Project Name: Forest View - HVAC

Project No.: 221125-260

This Addendum is issued to inform the bidders of modifications in the scope of work being bid for this project.

END OF ADDENDUM NO. [#2]

RFI #6: Detail 4 S0.1 - Beam pocket not shown

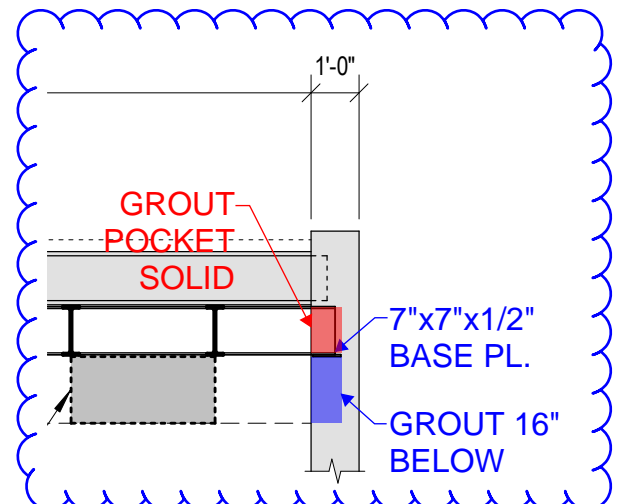
On S0.1 detail 4 there appears to be a support required for the added steel, but no beam pocket/grouted infill/plate is indicated. Please verify requirements for additional supports required on this added area.

FIRST FLOOR MECHANICAL PIPING PLAN - UNIT 300
SCALE: 1/8" = 1'-0"

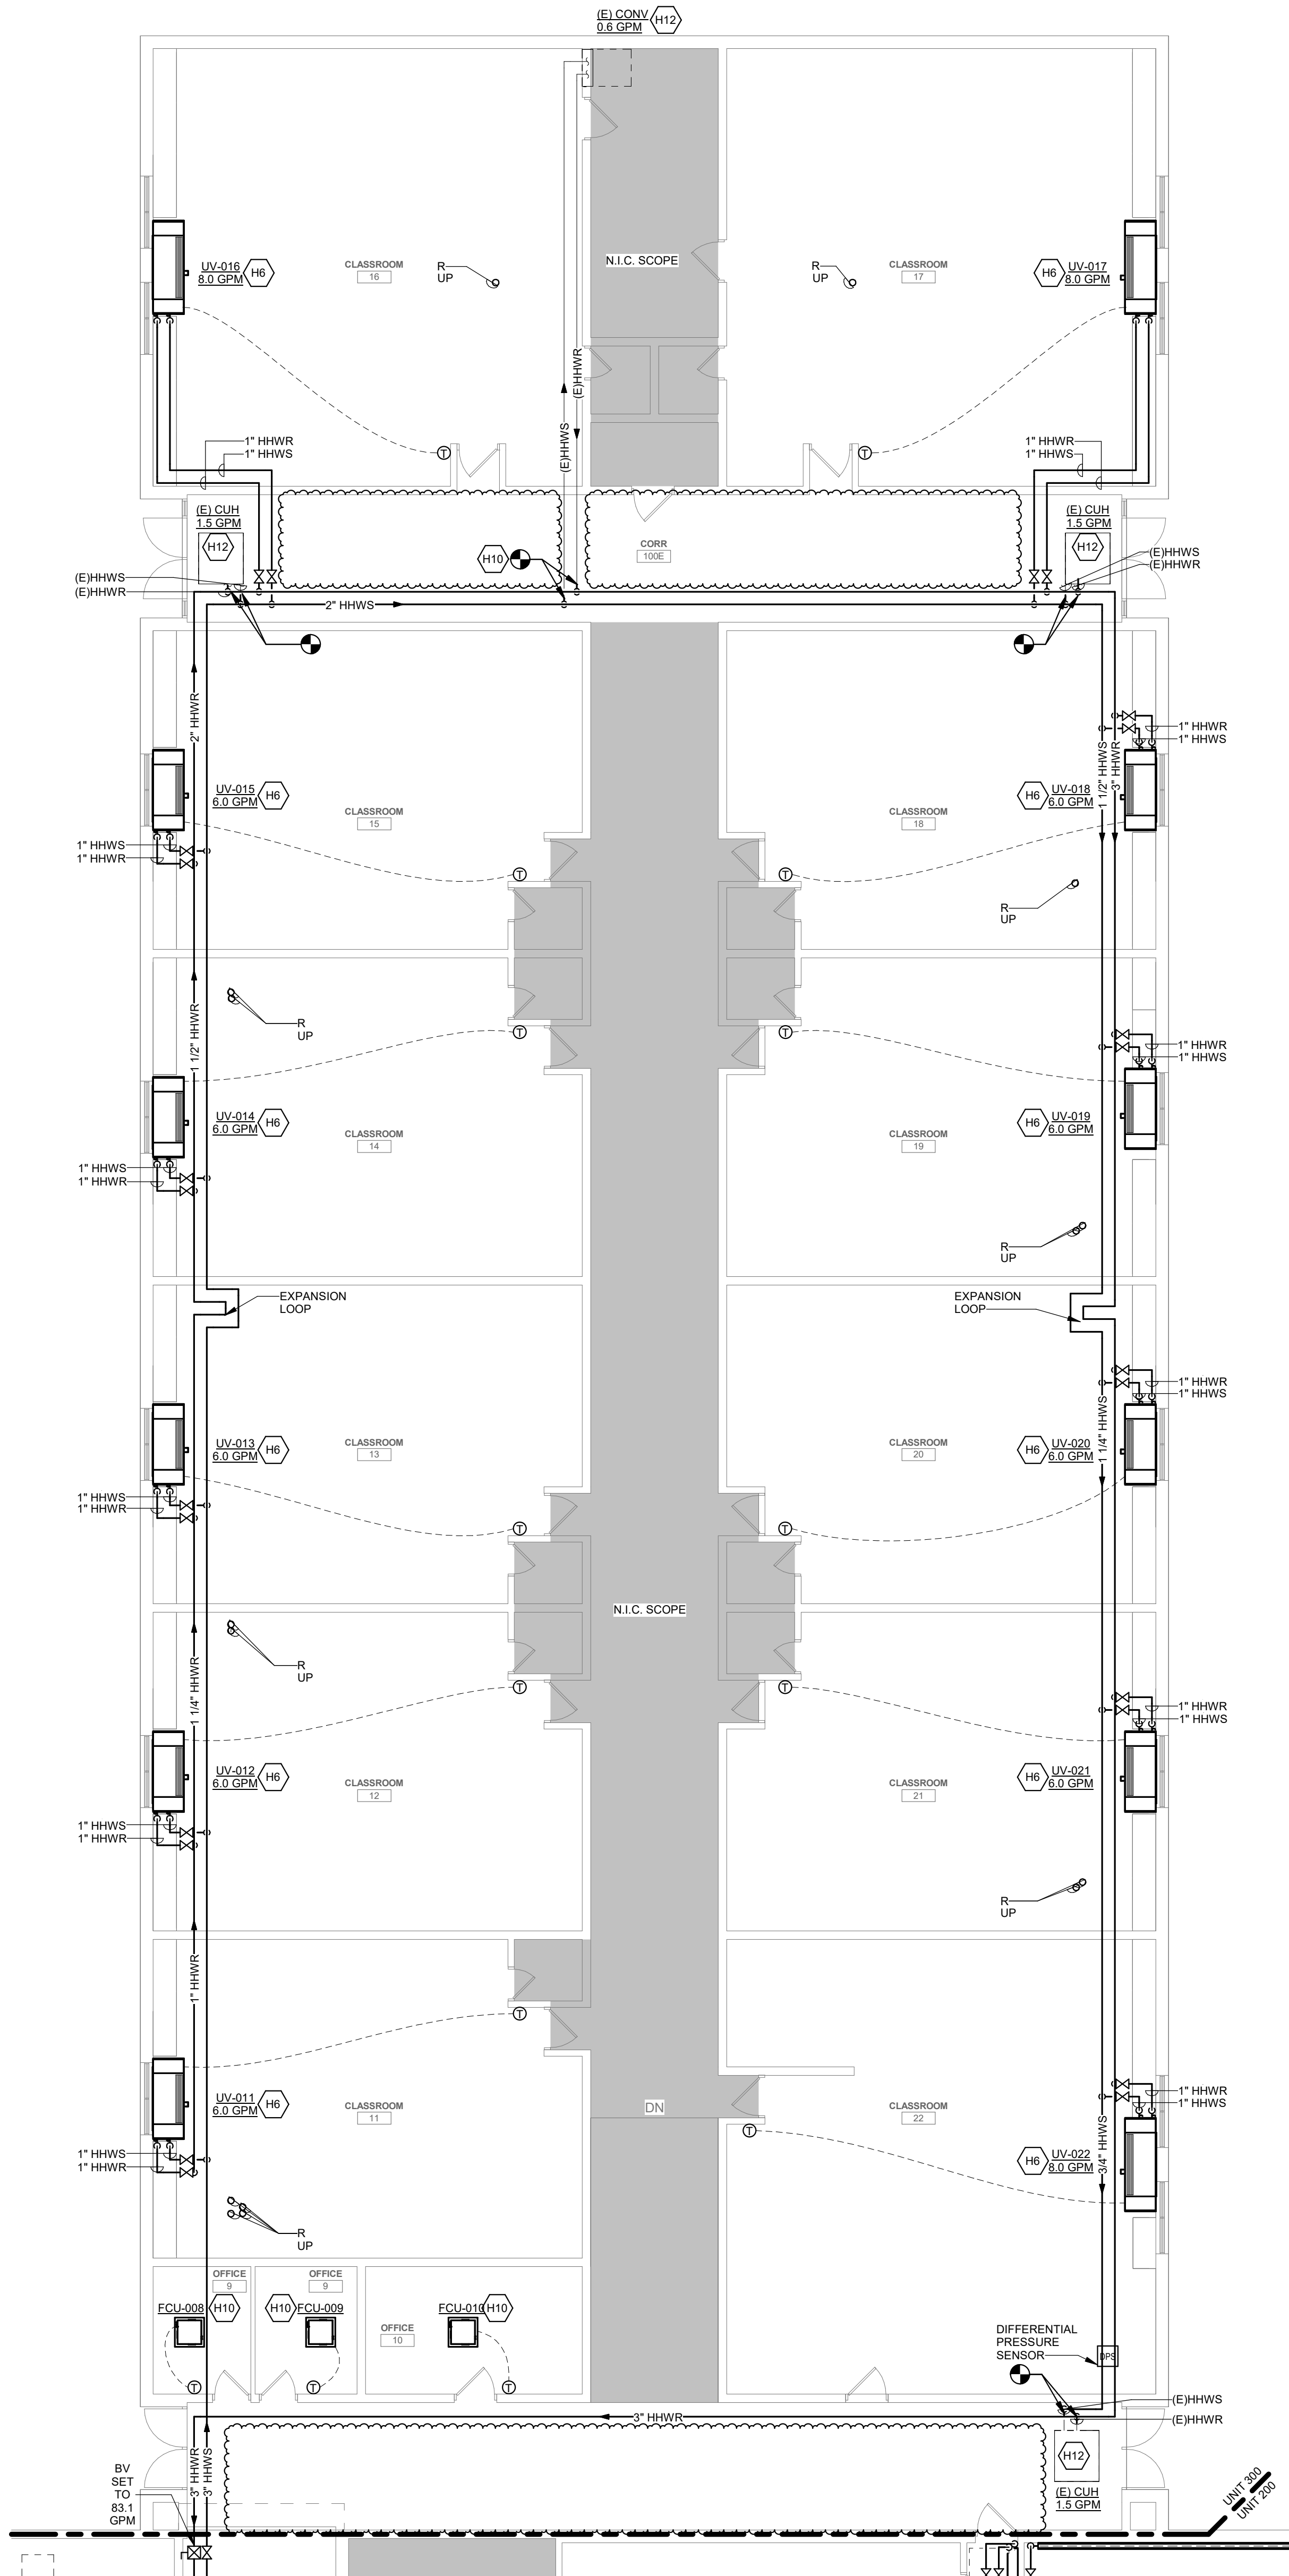
- Revised N.I.C. scope area to indicate correct scope of work.

ENLARGED MECHANICAL ROOM DEMOLITION PLAN
SCALE: 1/4" = 1'-0"

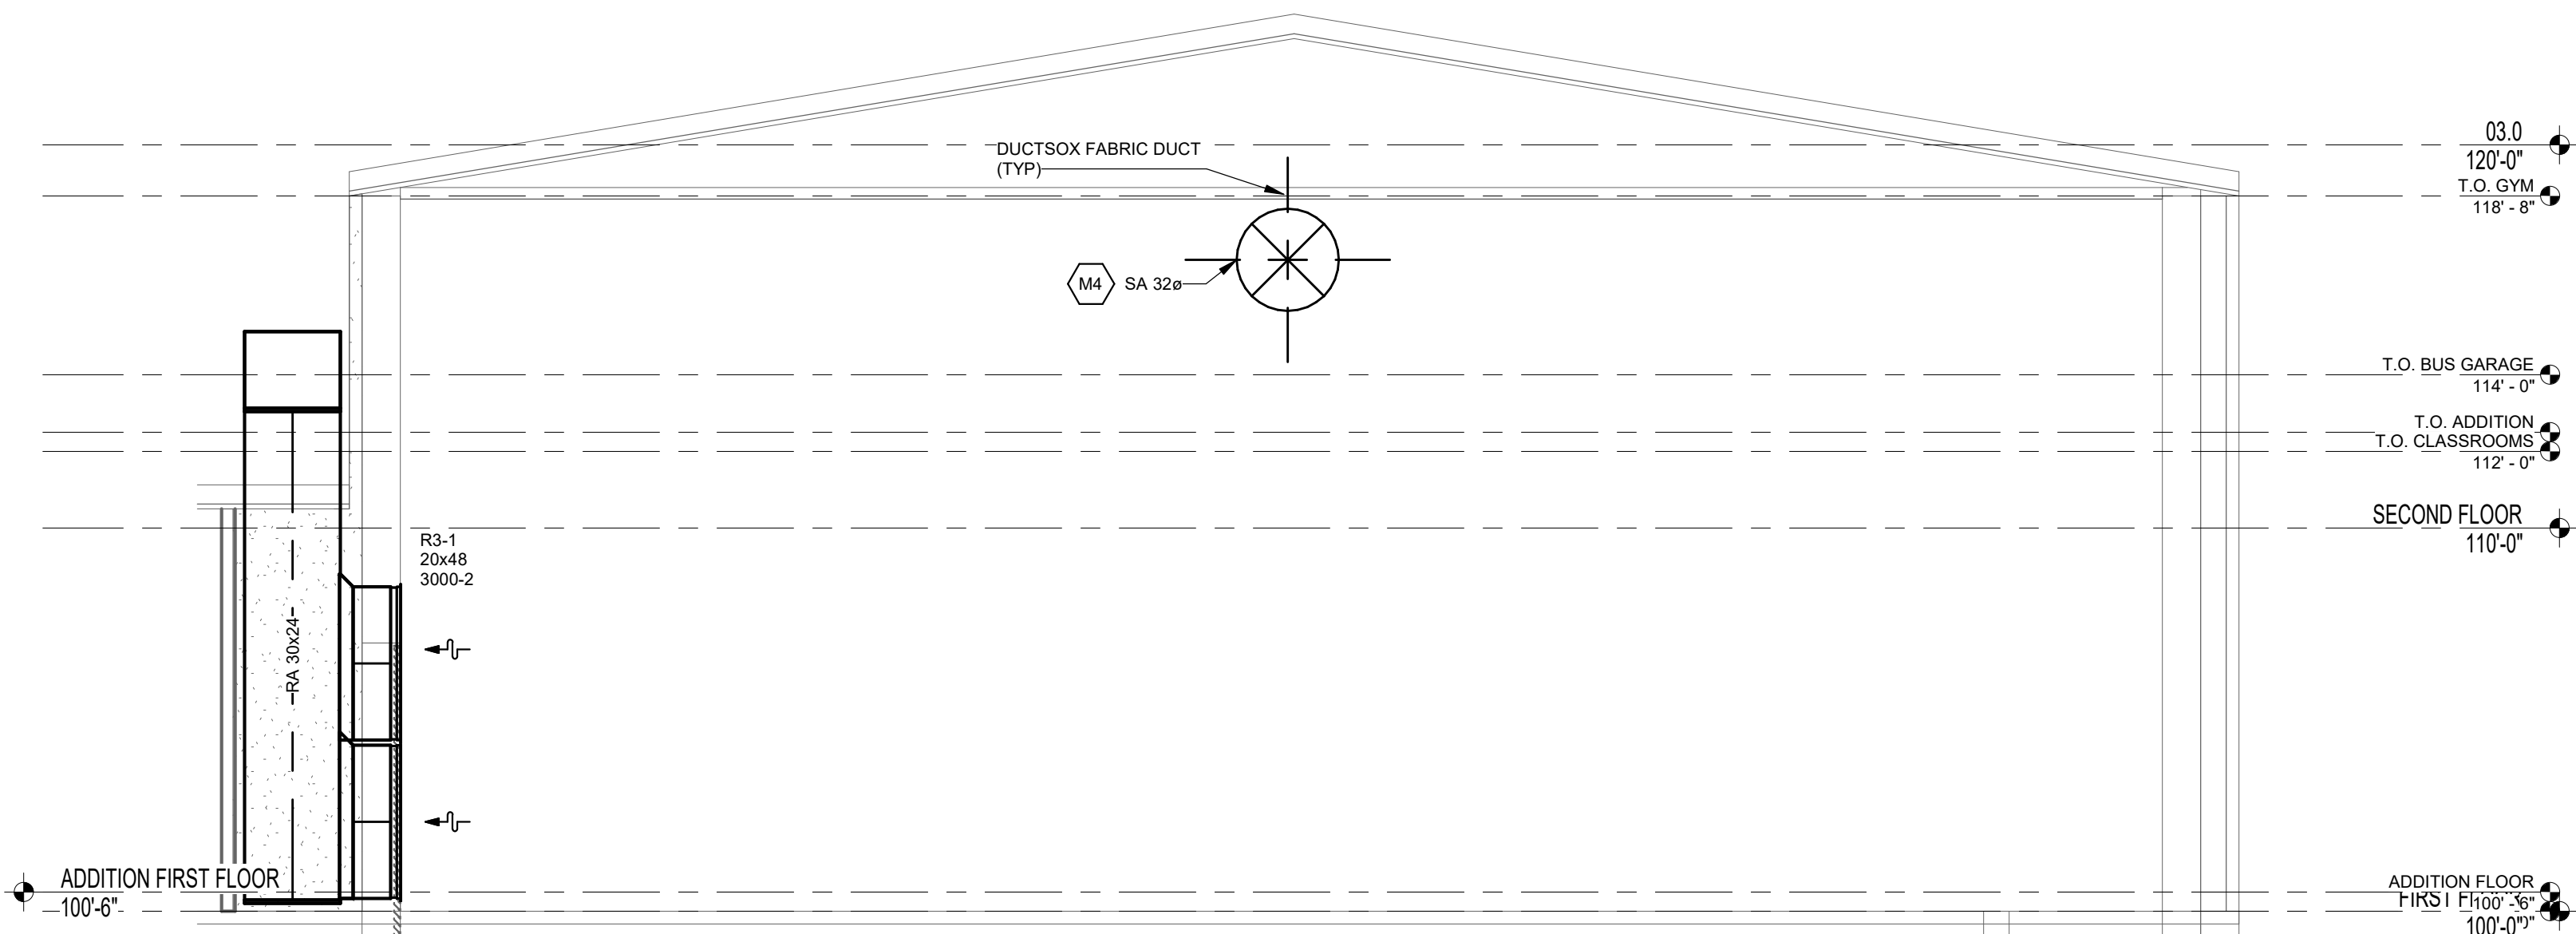
- Revised piping layout to show a primary/secondary system in lieu of a variable primary system.
- RFI #4 – Revised P-1, P-2 locations to avoid conflicts with clearances from existing panels.
- Revised demolition keynote language.
- Added mechanical demolition general notes to sheet.

HEATING HOT WATER SYSTEM PIPING DIAGRAM
NO SCALE

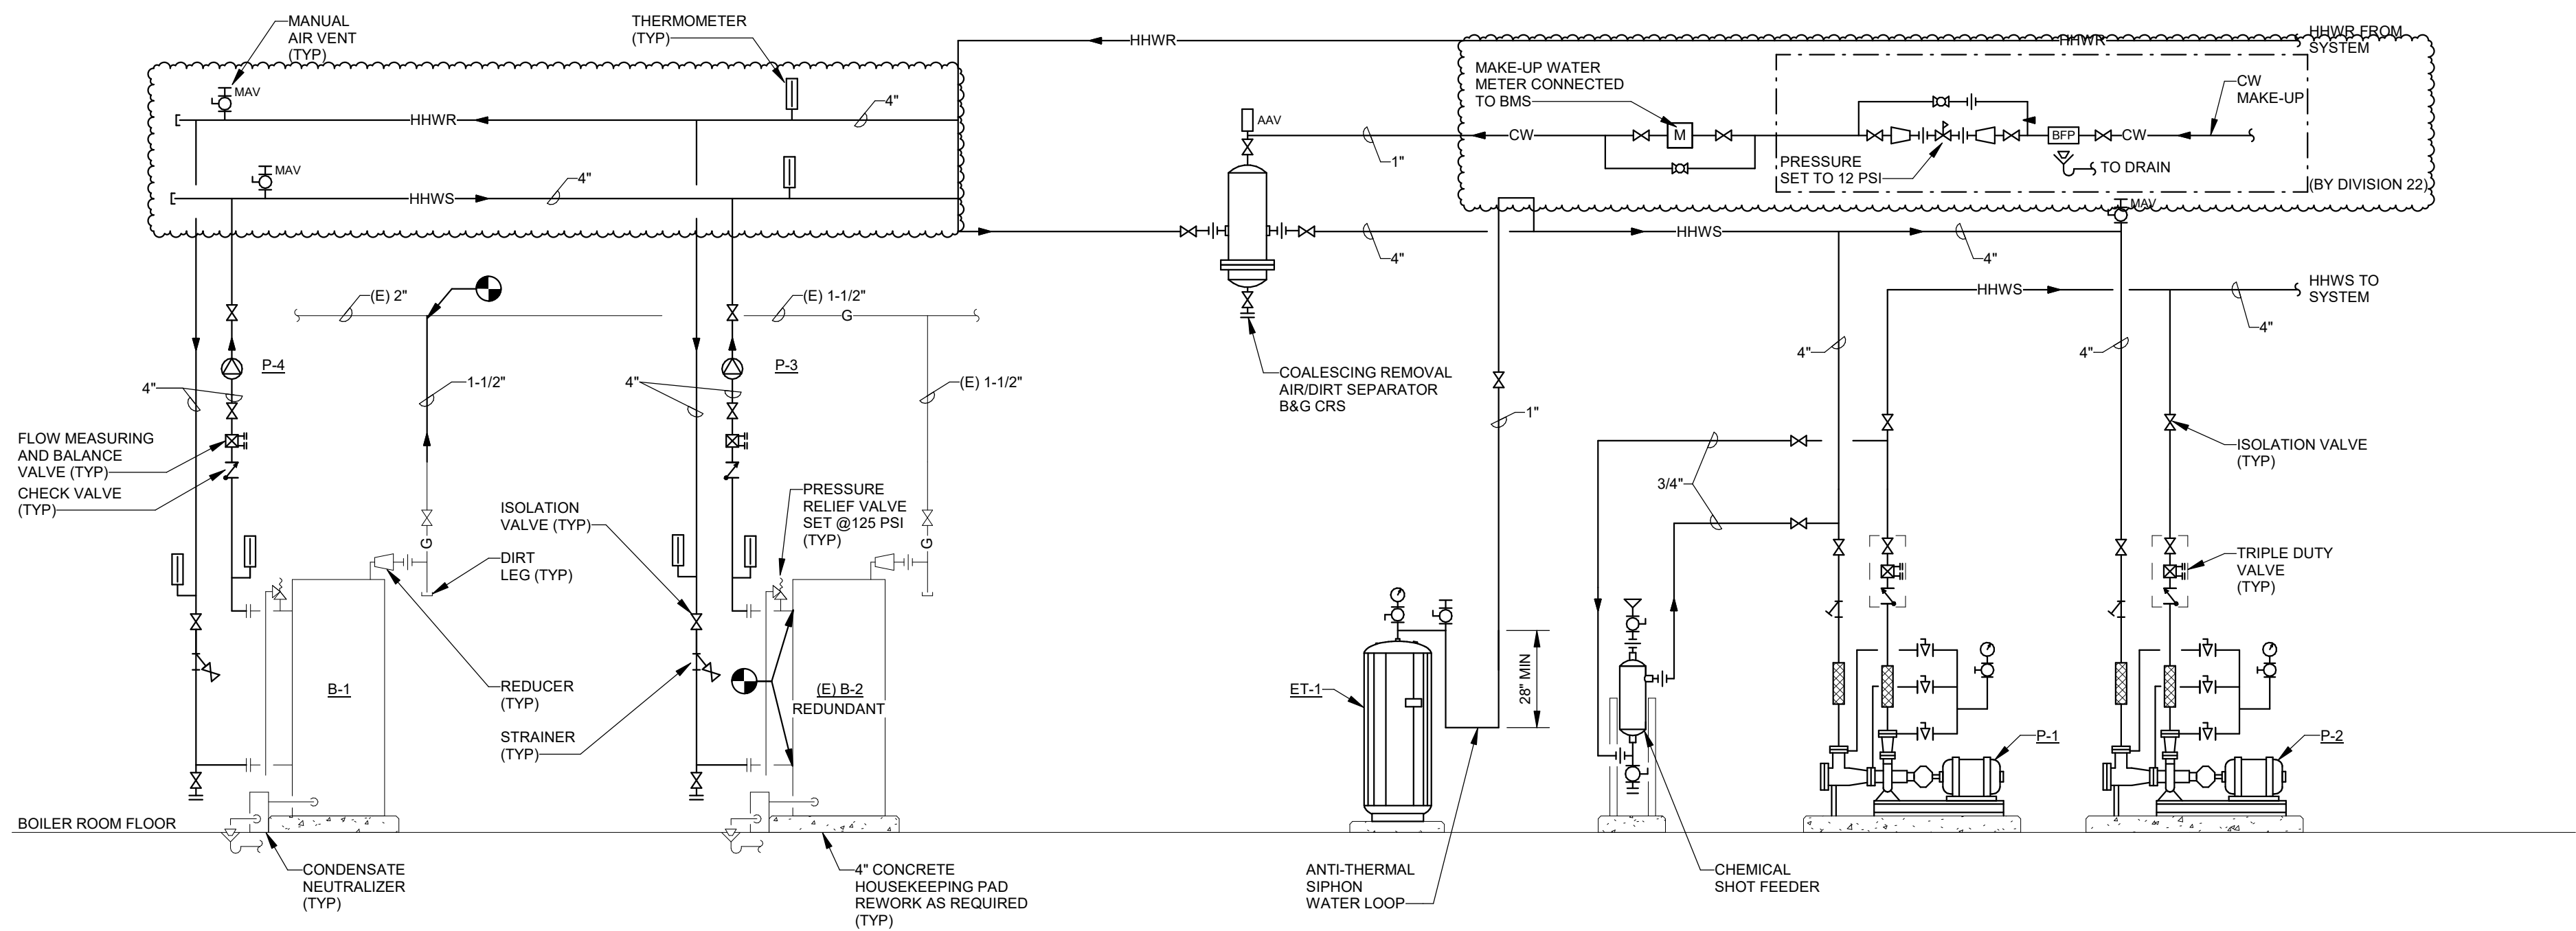
- Revised piping diagram to show a primary/secondary system in lieu of a variable primary systems.
- Edited gas riser diagram to clarify existing vs new scope better.
